Application for Licence Amendment

Licence Number	L6818/1997/11
Licence Holder	Shire of Bridgetown-Greenbushes
File Number	DER2015/000123-1
Premises	Bridgetown Waste Management Facility Lot 903 Bridgetown-Boyup Brook Road BRIDGETOWN WA 6255 Legal description – Lot 903 on Plan 189961 As defined by the Premises map attached to the Revised Licence
Date of Report	10 April 2025
Decision	Revised licence granted

Figure 1: Proposed location of additional groundwater monitoring wells

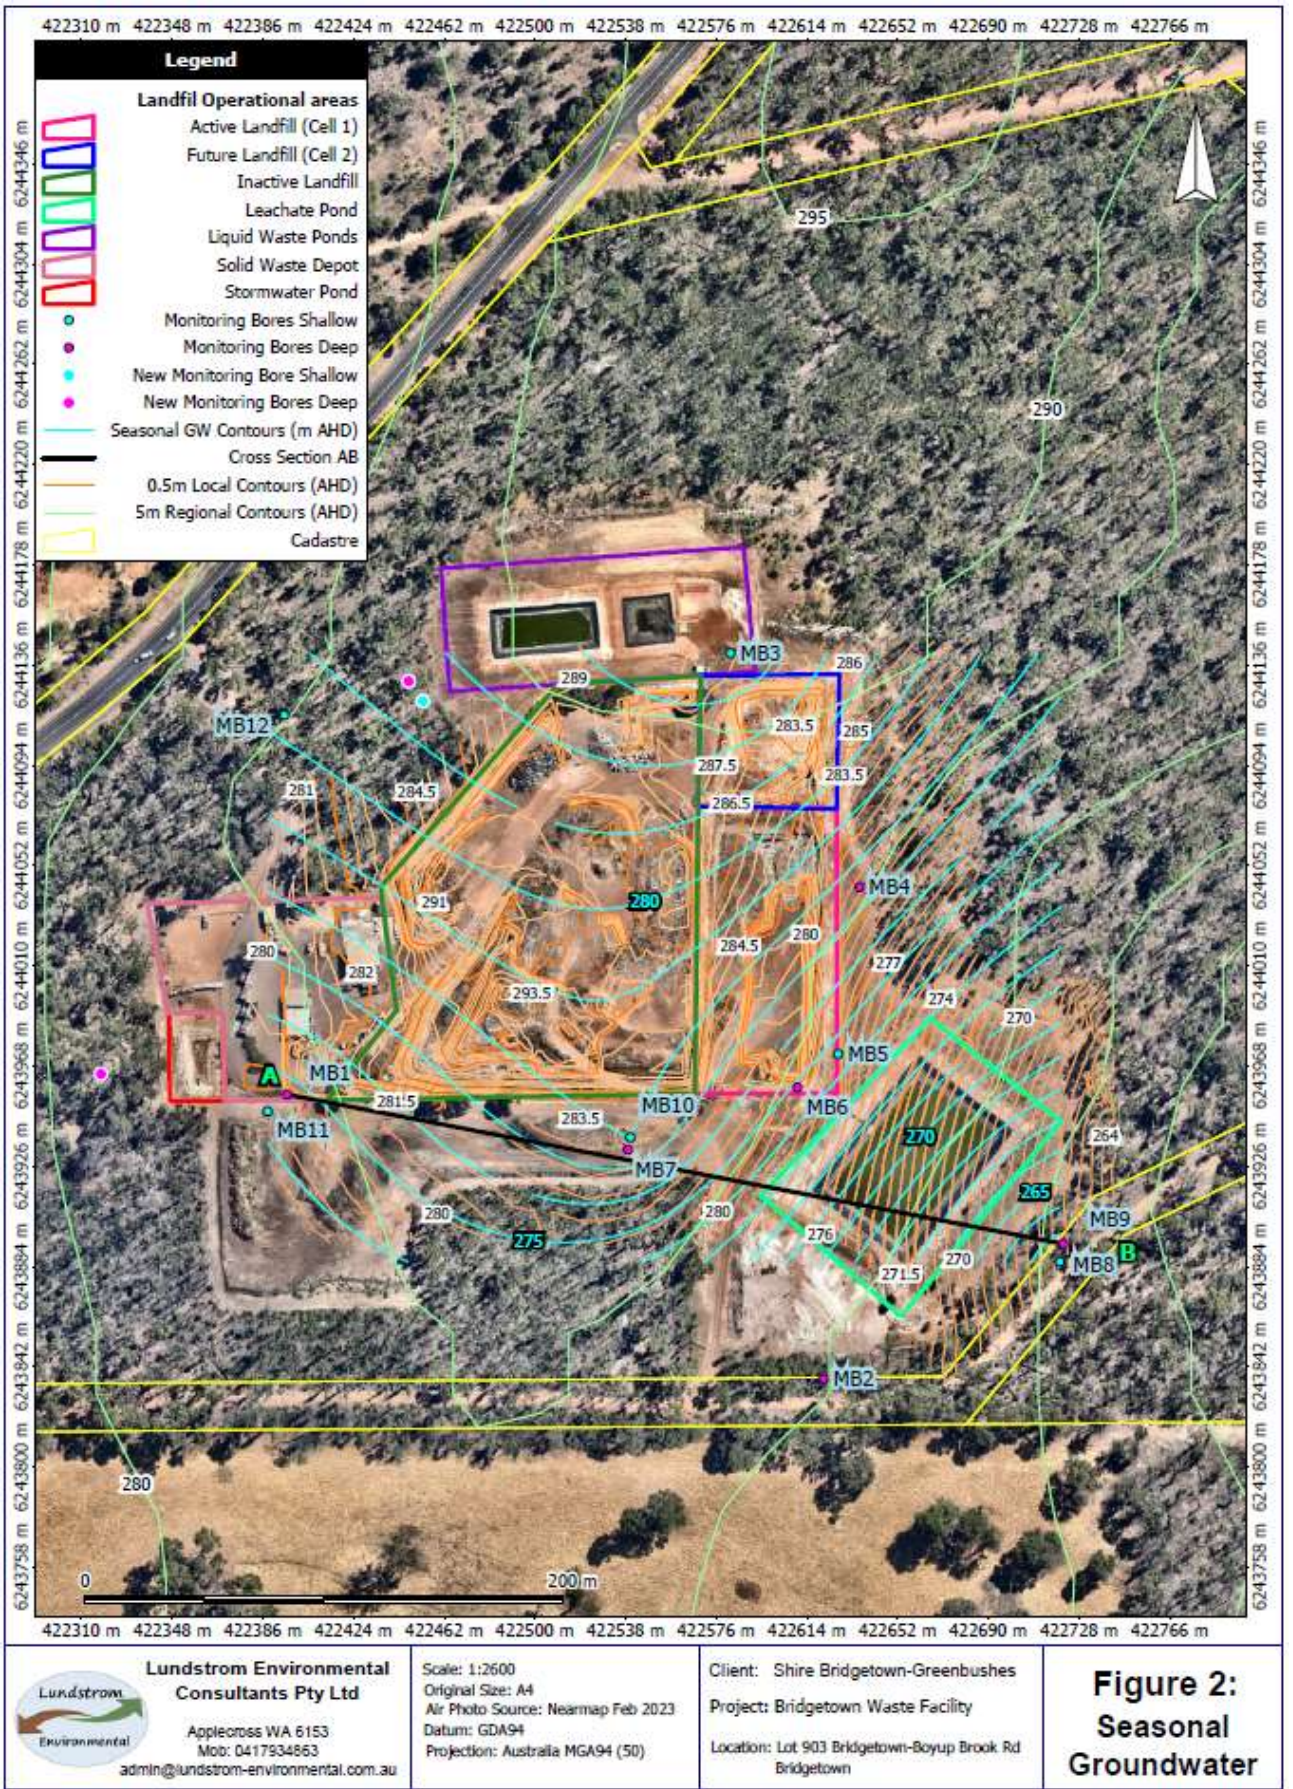
1. The installation of new monitoring bores along the western boundary of the premises in accordance with Figure 1.
2. A full suite of water level readings to be undertaken to allow for groundwater levels across the site to be modelled.
3. The analysis of monitoring bore MB8 water quality results in conjunction with MB5 results determine if contamination identified in this well originates from the leachate pond or the active landfill cell.
4. An additional shallow groundwater monitoring bore to be installed just north of MB4 if the Shire proceeds with the future landfill cell proposed.

9. There are '*large gaps in the monitoring of the spatial distribution of groundwater quality, particularly to the west and east of the main landfilling area*'. To fill the gaps in the current groundwater monitoring network, CSB has considered that additional monitoring wells should be installed. However, it is essential that monitoring wells are correctly located. There is insufficient information currently available to suggest appropriate locations for additional bores as groundwater is not uniformly distributed in regolith and in fractured bedrock in the area. Therefore, CSB has recommended that a ground-based geophysical survey is undertaken using electrical techniques which would identify subsurface conductive anomalies. This would indicate the significant groundwater flow paths and targets for monitoring well installation.

However, based on the advice from CSB, the Delegated Officer considers that further investigations are required prior to installing new bores to ensure that they are installed in the most appropriate locations to fill existing data gaps. Therefore, the requirement to undertake a ground-based geotechnical survey using electrical techniques to identify suitable locations for additional monitoring wells has been conditioned in the Licence. The Licence Holder will be required to provide the survey results and proposed groundwater monitoring well locations to the department for review prior to well installation.

Figure 2: Generic conceptual model of groundwater occurrence in granitic basement rocks that are overlain by a lateritic weathered profile. Figure from Ohenhen et al. (2023)

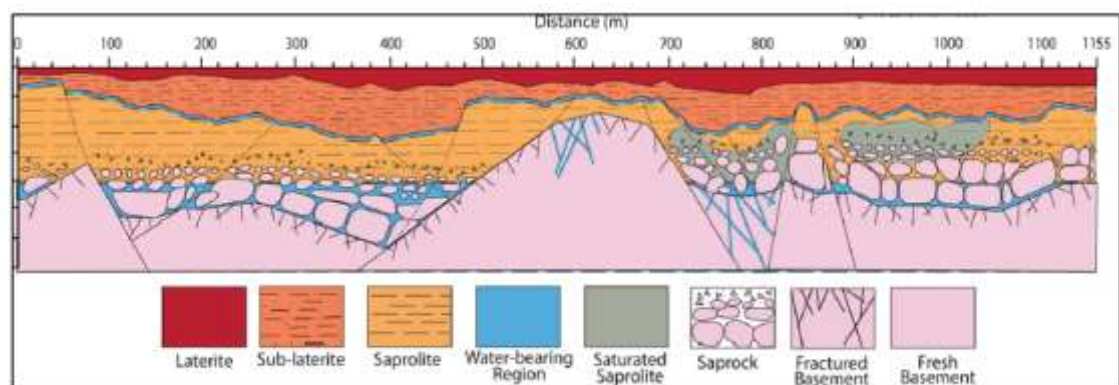
3. Basement rocks near the premises are overlain by an approximately 25-30 metres thick typical weathered profile. *'This profile consists of a near-surface ferruginous duricrust and pisolitic gravels (colloquially called "laterite") which are typically underlain by mottled ferruginous sandy clays that may contain abundant permeable root channels (often called the "mottled zone" or "sub-laterite")'. The mottled zone is in turn underlain by white sandy clays known as "saprolite"... or the "pallid zone". The saprolite probably has a gradational contact with partially weathered rock ("saprock") near the base of the weathered profile.'* The generic conceptual hydrogeological model that likely applies to the premises is shown in Figure 2.

4. Figure 2 indicates that a thin perched aquifer may develop seasonally near the interface with the underlying saprolite. However, perching may also take place at the base of the ferruginous duricrust near the surface (laterite). Due to the presence of macropores in the perched aquifers, hydraulic conductivity may be very high, allowing contaminants to be rapidly transported in shallow groundwater flow several hundred metres to areas of discharge. Contamination of groundwater in the deeper aquifer from surface land use activities may only occur where there is a high level of hydraulic connection with the

Figure 3: Spatial distribution of bicarbonate ions in groundwater (mg/L) from the shallow and deep aquifer samples collected in November 2022.

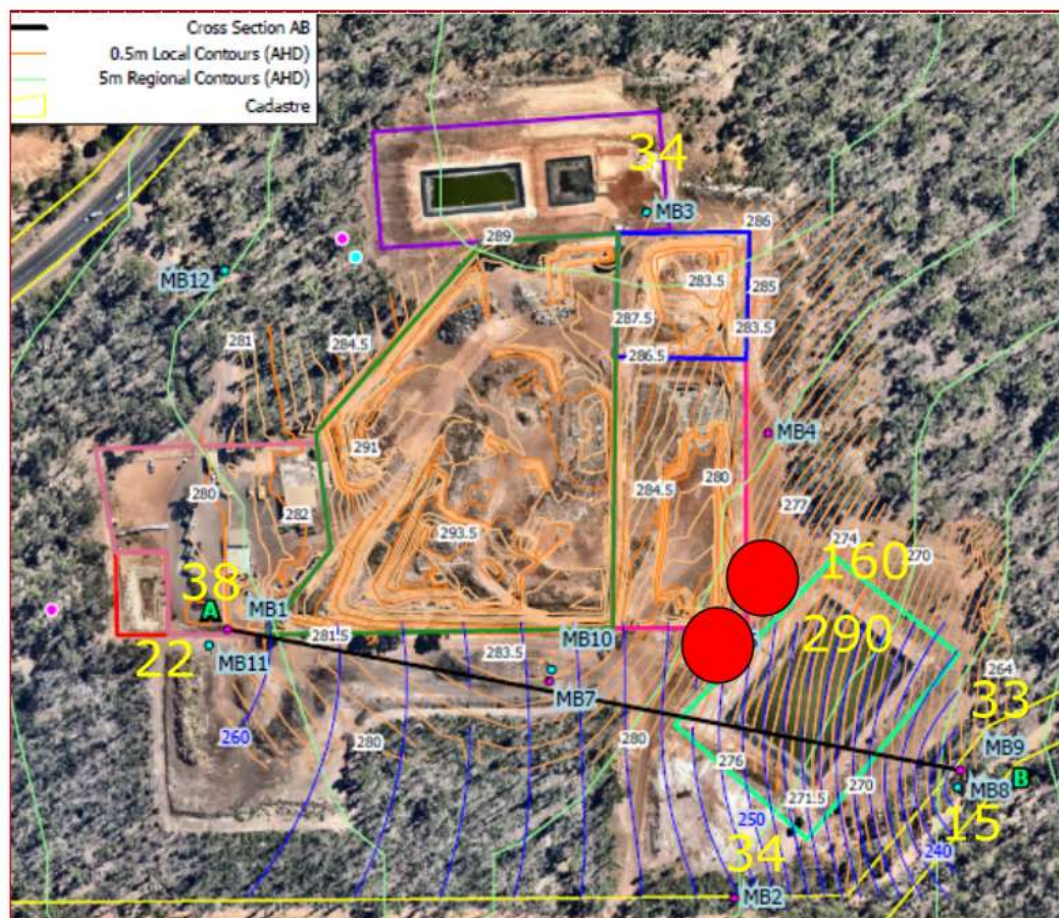
6. There is evidence of groundwater contamination at the premises by leachate landfill. Changes in bicarbonate ion concentrations are considered the greatest indicator of leachate contamination. Groundwater monitoring results from sampling events on the premises showed elevated bicarbonate ion concentrations (up to ten times background levels) in shallow and deep aquifer wells near the southeastern corner of the site (shown by filled red circles in Figure 3). This suggests localised contamination has occurred in this location and is also supported by elevated levels of total nitrogen.
